**Draft Planning Scheme Amendment C124cola  
Referral 38: 130-154 Sinclair Street South, Colac**

**Priority Projects Standing Advisory Committee Report**

**19 February 2024**

Figure 5 One per cent AEP existing conditions flood modelling results

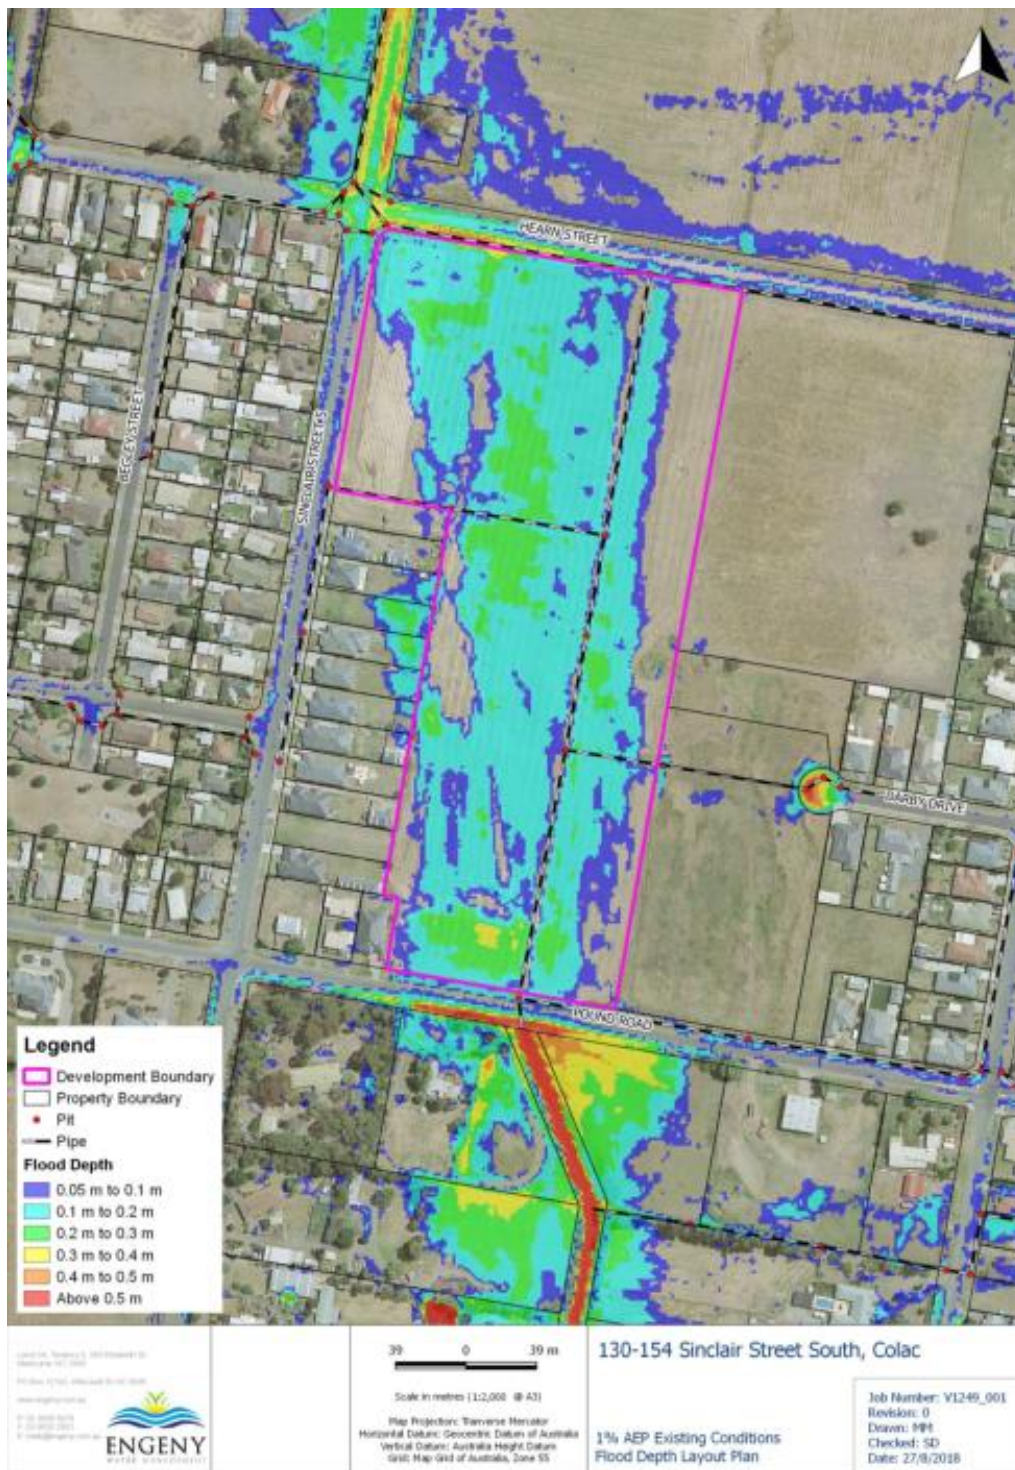
Ablut called drainage and flood modelling evidence from Scott Dunn of Engeny Pty Ltd. Mr Dunn referred to the *“significant flood depth differences”* between the Flood Study and the SWMS, attributing this to the *“incorrect application of a manning’s roughness value”* and the exclusion of Council drains in the Flood Study.

Mr Dunn’s statement contained an updated map of flood depth, which he said *“displays a more accurate representation of the existing conditions”* (see Figure 5).

**Figure 6** One per cent AEP flood depth different due to developed conditions

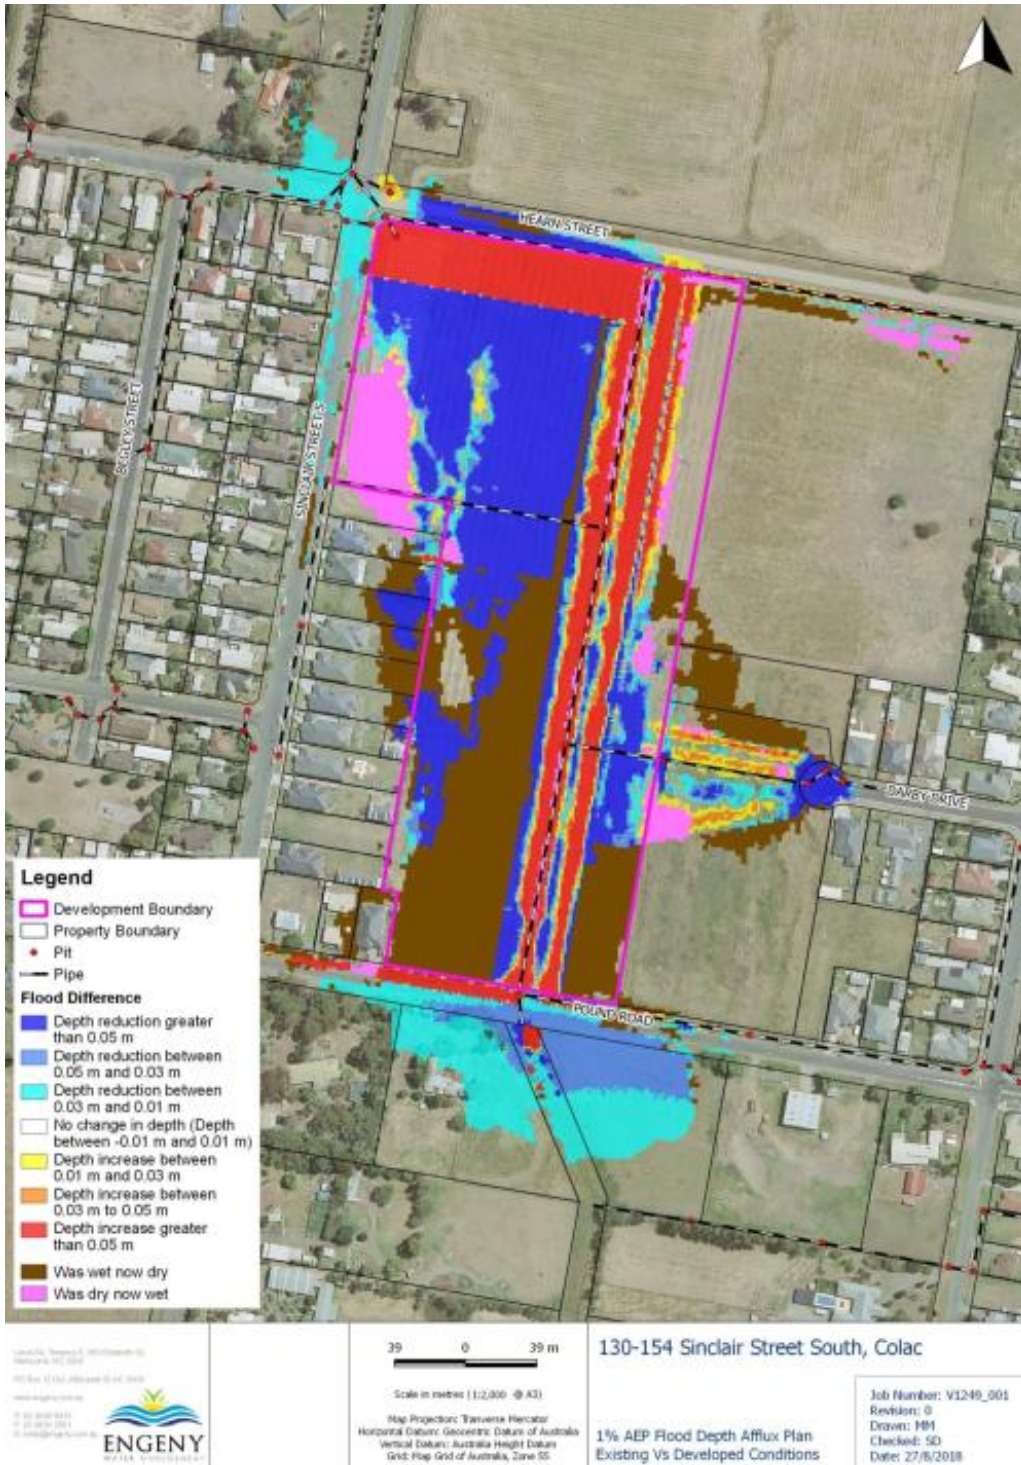
Mr Dunn pointed to the multiple mitigation measures proposed as part of the development, including:

- a 3000 cubic metre retarding basin in the north-west corner
- an enlarged drainage pipe running north-south through the subject land
- a wider main road reserve providing overland flood storage and passage
- assorted culvert upgrades on surrounding streets.

The result of these mitigation measures was shown on a plan prepared by Mr Dunn comparing pre and post developed conditions (see Figure 6).

Because of the proposed mitigation measures, Mr Dunn said that outside the subject land, and particularly along Hearn Street, the projected flood depths would be reduced. Mr Dunn said the “technical assessment of flooding for the subject site is of sufficient rigour and accuracy to confidently support Planning Scheme Amendment C124COLA”.

The Committee is comforted in the comprehensive SWMS already prepared, and notes the extensive mitigation measures proposed, including a large retarding basin, drainage pipe enlargements, and a specially designed road reserve to accommodate overland flow. The modelling in the evidence of Mr Dunn, which the Committee accepts, shows this will appropriately manage flooding and stormwater on the subject land, and not worsen flooding outside the site, including on Mr Garner's property. However, the final say on the SWMS and its initiatives will lay with Council and the CCMA as part of the subdivision permit.
